Meadowbank 2024 Annual Open Pit Geomechanical Inspection

**RE: Meadowbank Complex - Meadowbank Site - 2024 Annual Open Pit
Geomechanical Inspection**

Meadowbank Complex - Meadowbank Site - 2024 Annual Open Pit Geomechanical Inspection

Inspections

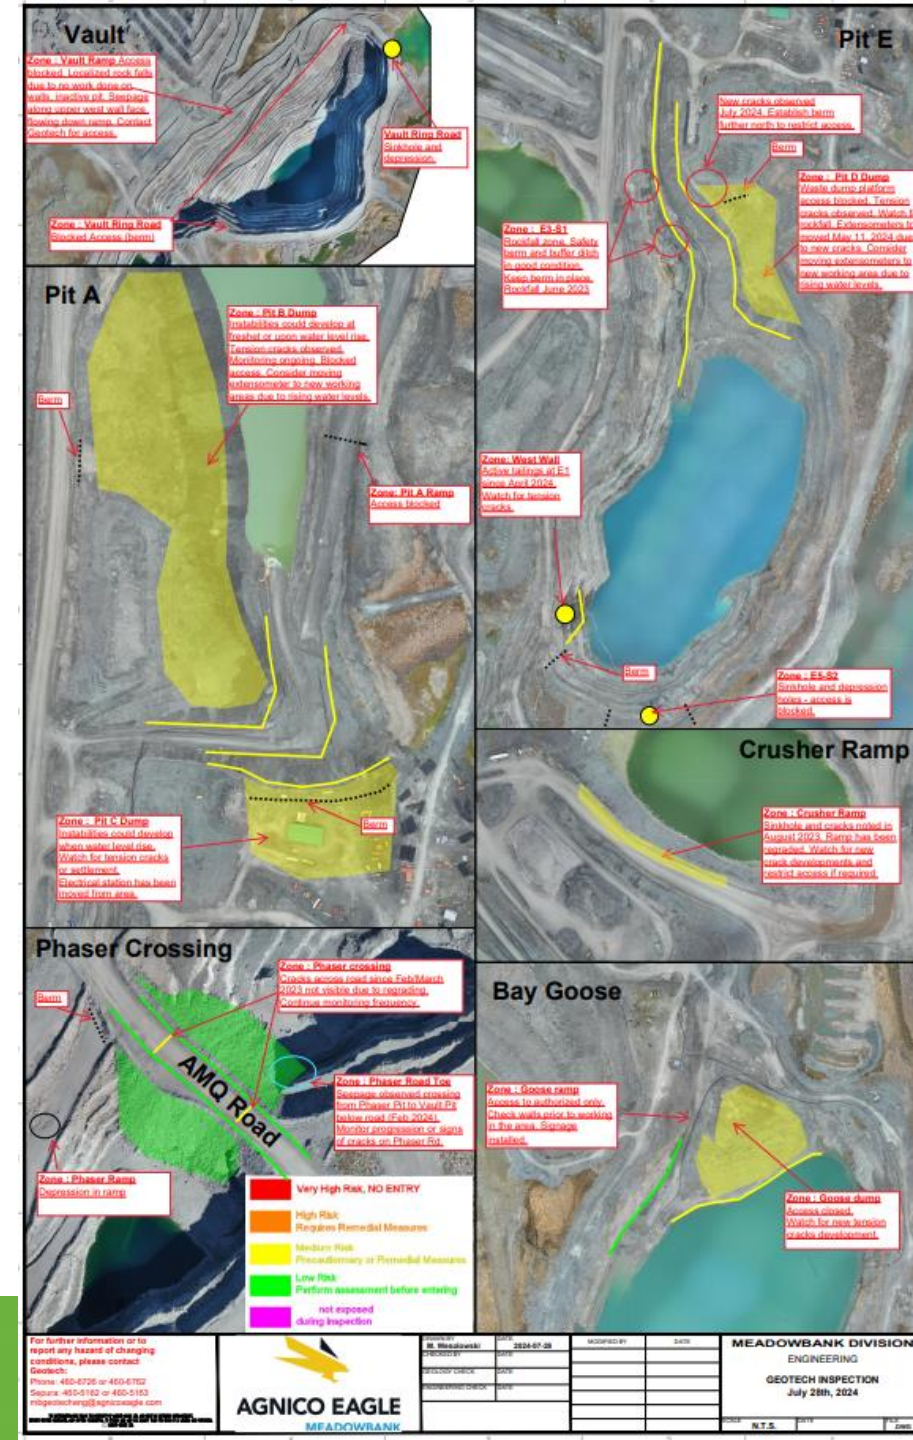
- Visual inspections are completed by the Geotechnical Group on a monthly basis (with some exclusions during the winter between October and February) and a summary report and map issued. The inspection procedure has been updated to define criteria when additional inspections are required.
- The personnel completing the inspections have changed over the last year. The inspections are now primarily completed by Michelle Wesolowski (Geotechnical Engineer).
- The Rock Mechanics Group commits to an over-inspection of the open pits and in-pit dumps at the Meadowbanks site once a year. This is now completed as part of this annual inspection.
- A selection of the inspection reports were reviewed. They are well-written and the key hazards identified during the 2024 annual inspection are included in the monthly reports.
